Ref: P23/S1564/CM

Re: R3.0138/21 Notice of Submission of Further Information

Proposal:

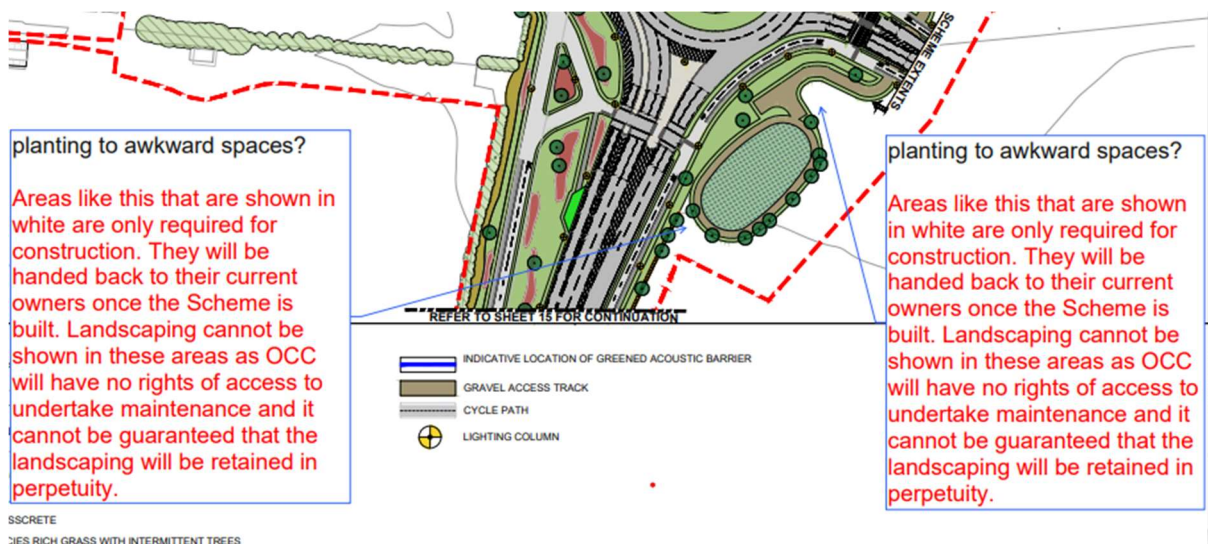
The response to landscape comments contained in Appendix C shows a lack of willingness to include even otherwise unusable areas of land for planting to help with mitigation. As shown on the extract from the application documents below, these awkward spaces will be of no use to the landowner, but to use them for additional planting would be beneficial in helping to screen the road and better integrate the scheme into the landscape.
